June 23, 2026**Addendum No. 04****File Reference Number: RFP 2026 031****Title: Cochrane Station Parking Lot Paving****RE: Additional work and clarification**

PROJECT TITLE
COCHRANE STATION PARKING LOT

DRAWING TITLE
ACCESSIBLE RAMP

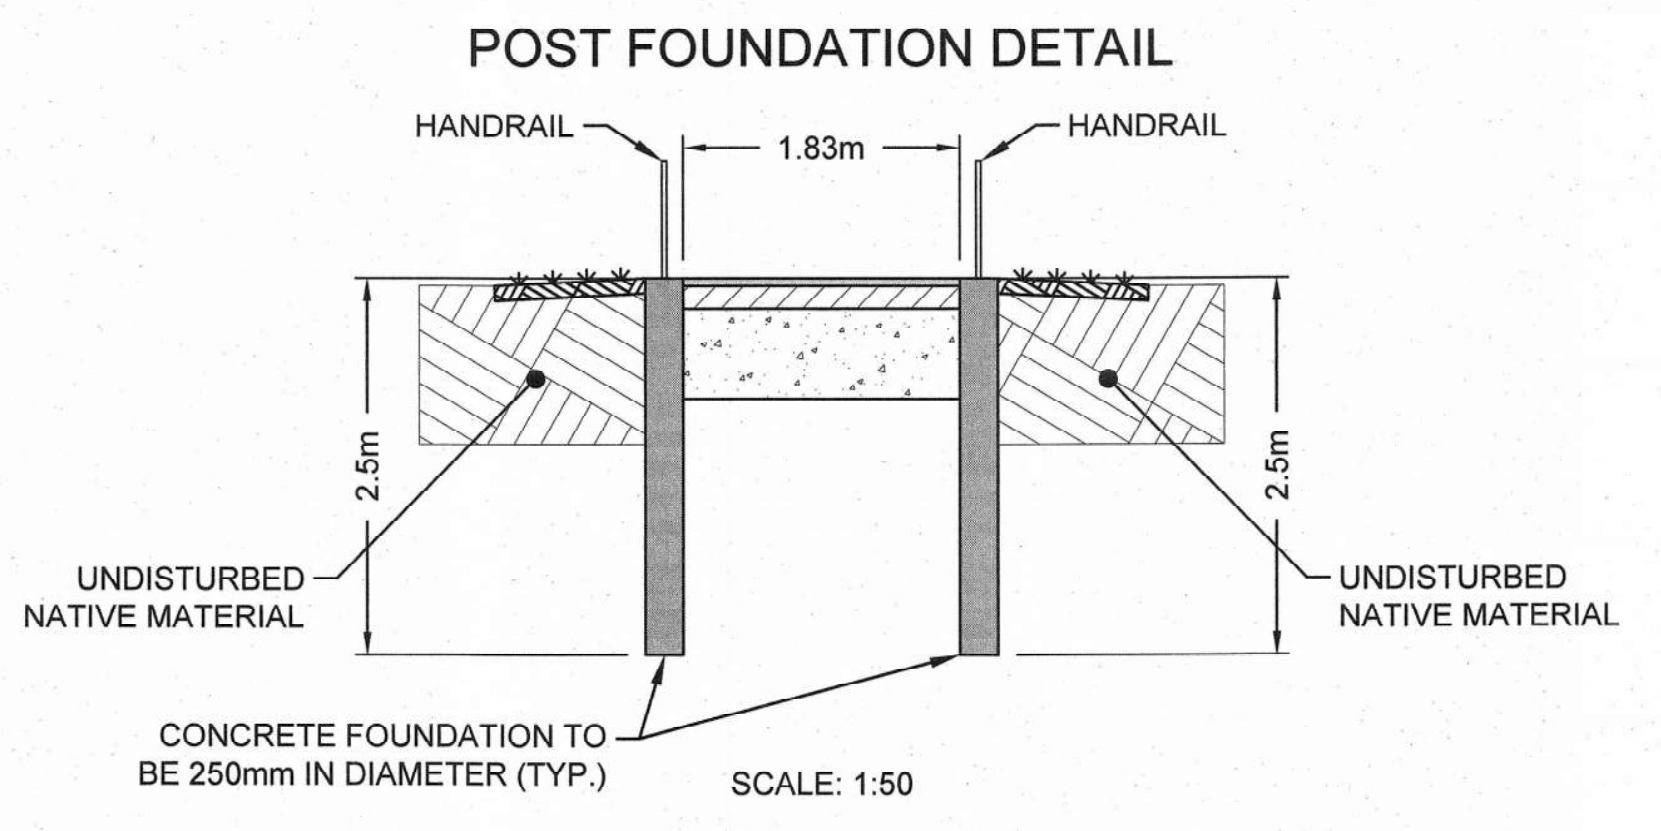
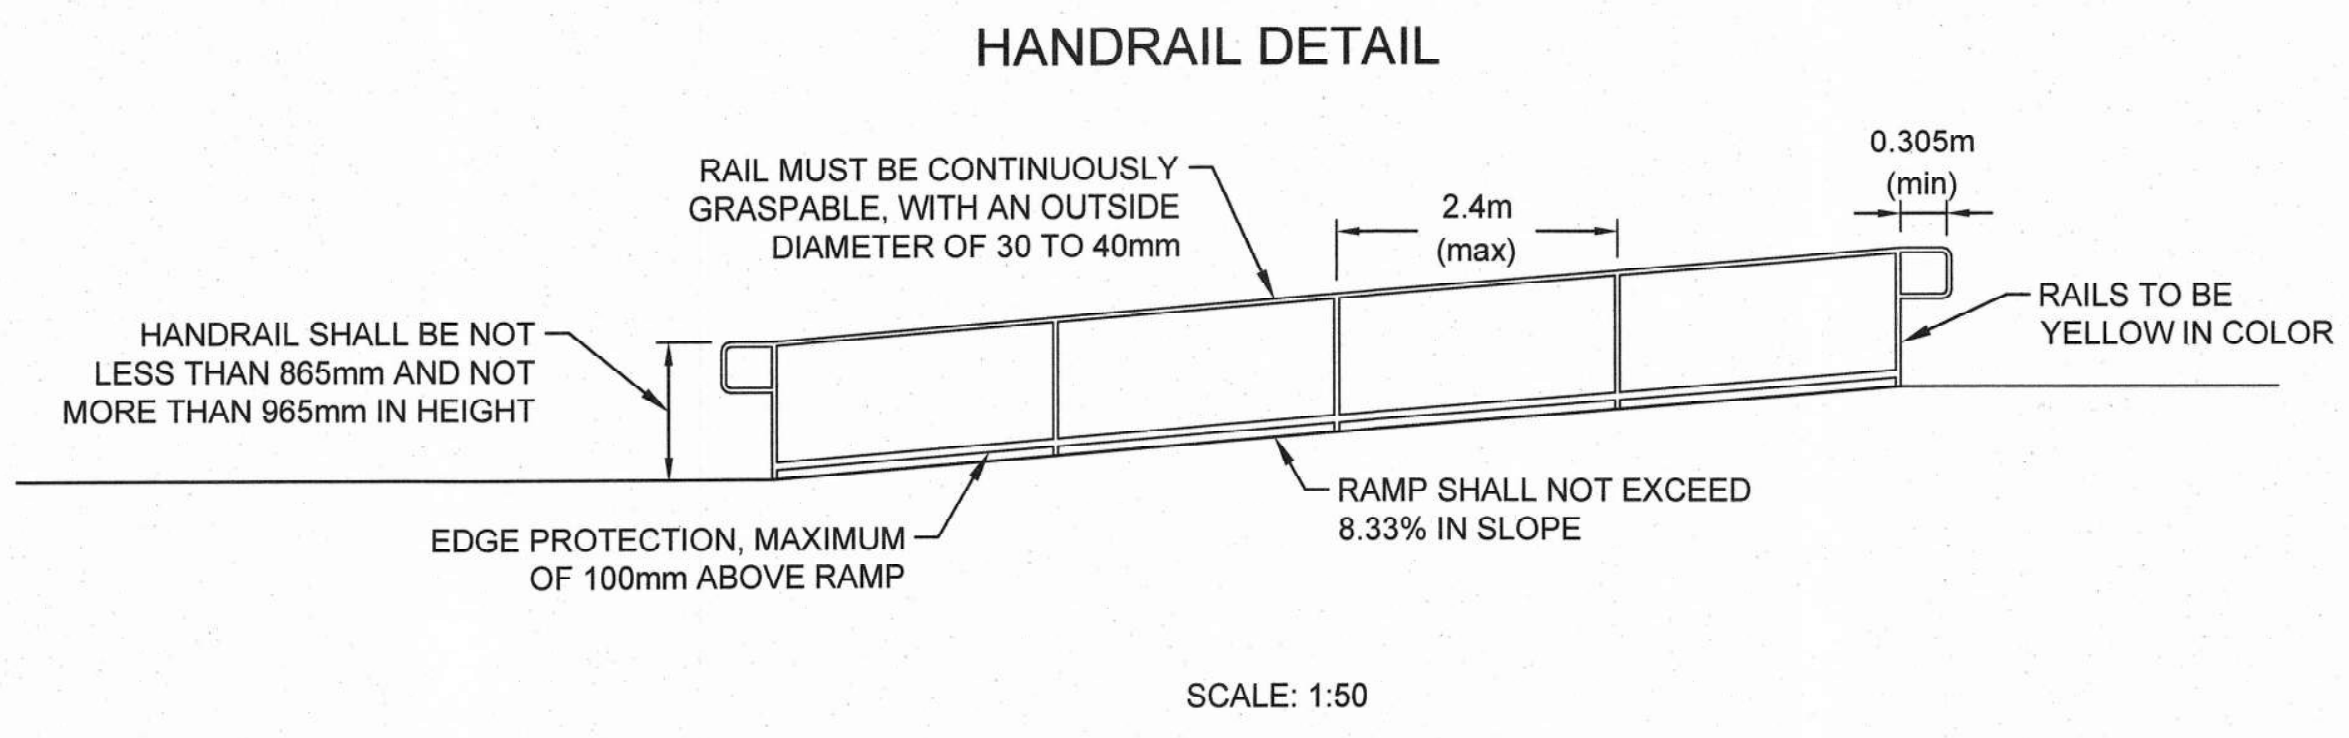
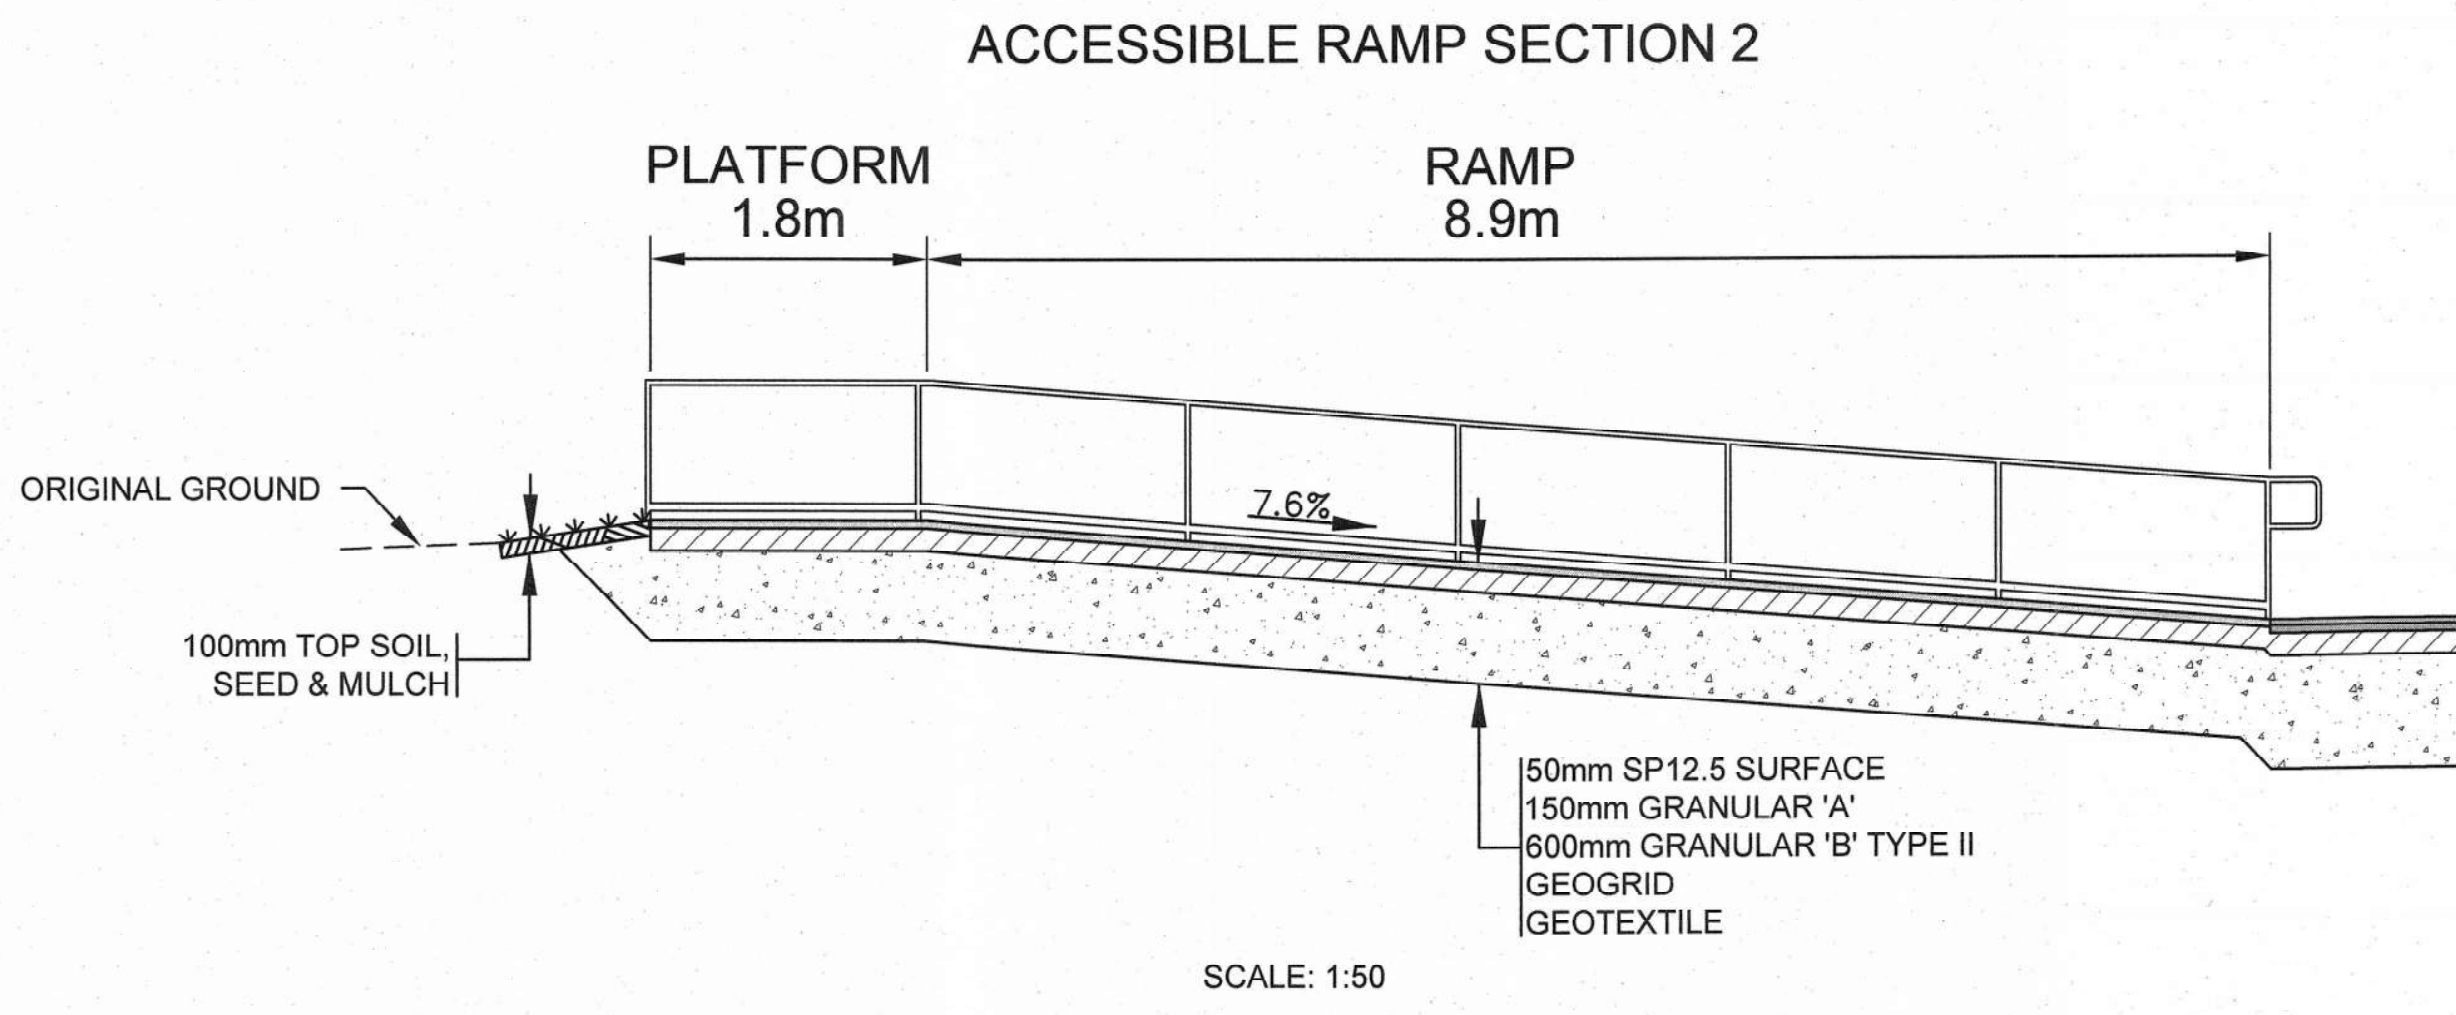
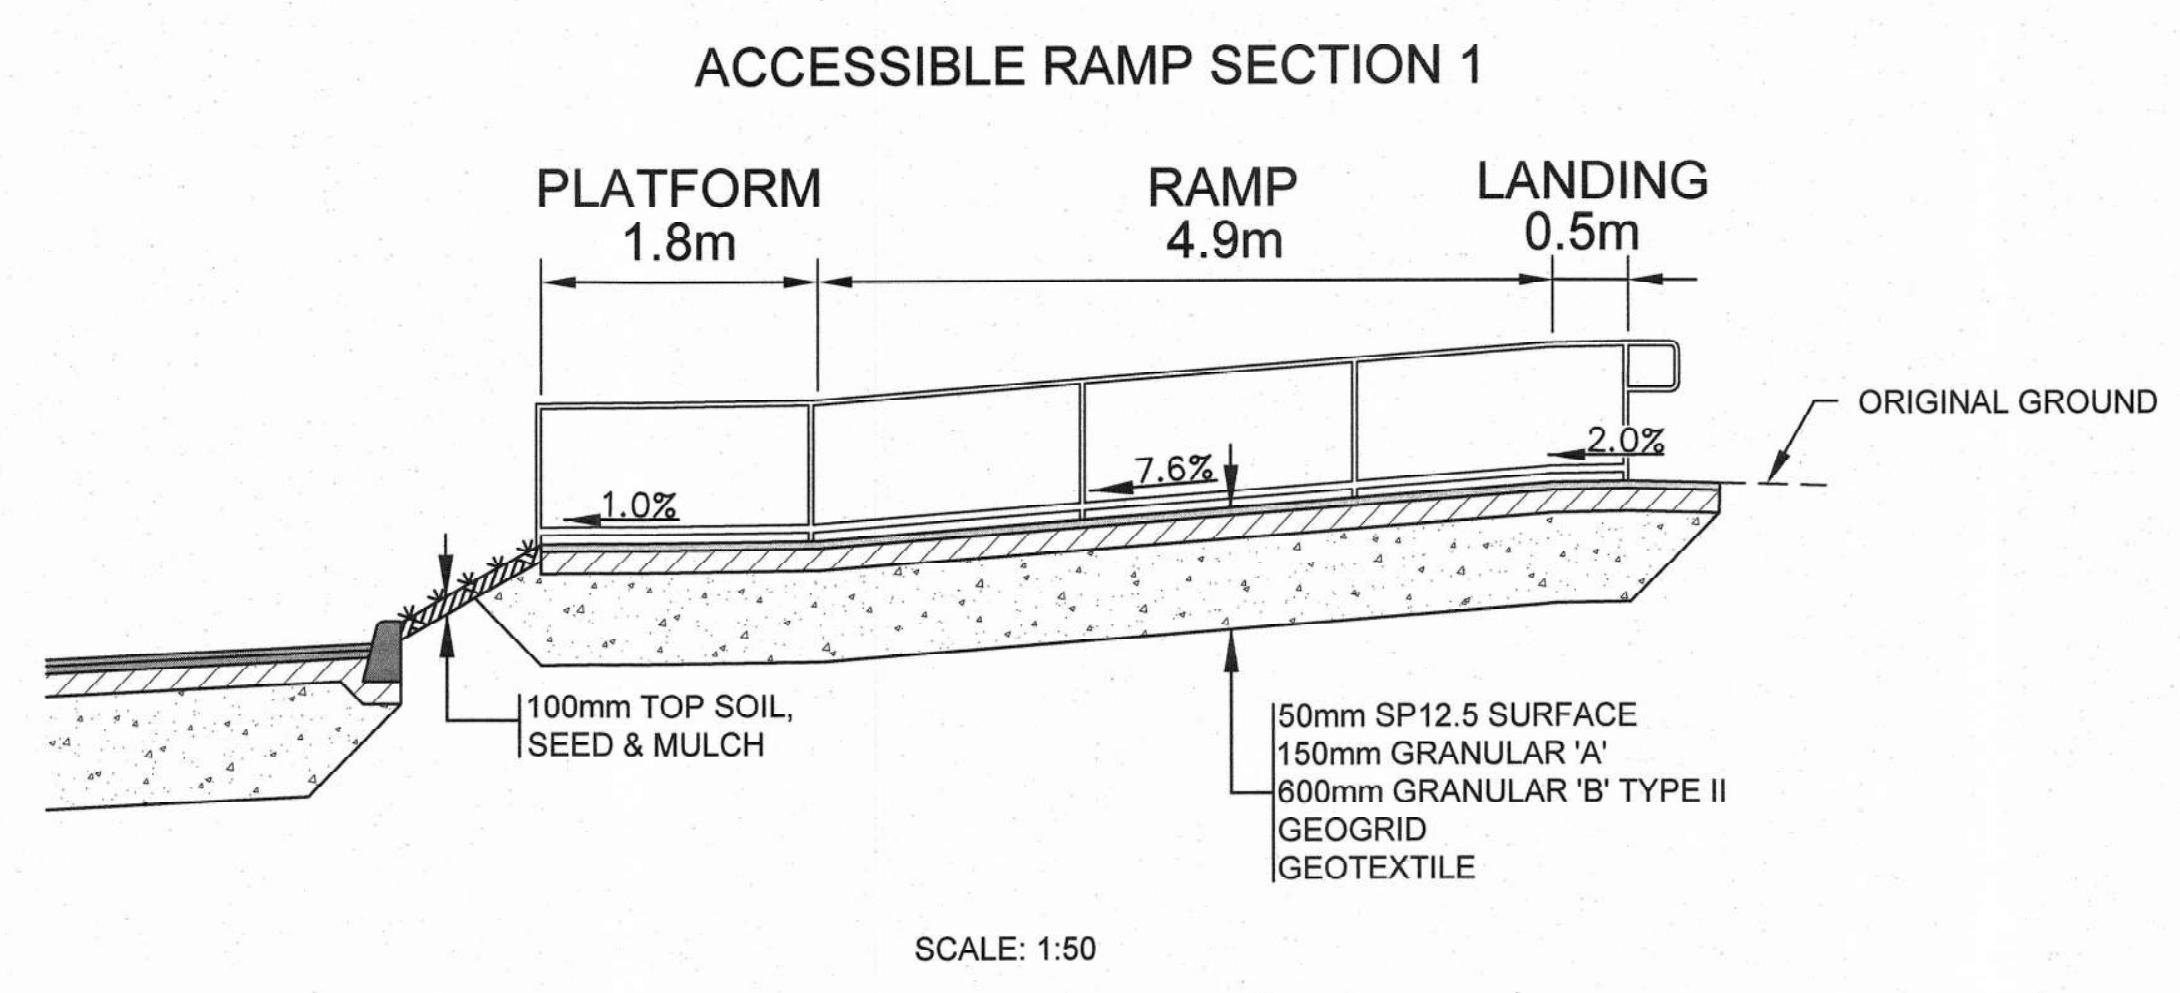
Item 2: Appendix H – Issue for Tender Drawings

Please find attached the Additional Ramp Drawings at the end of this Addendum.
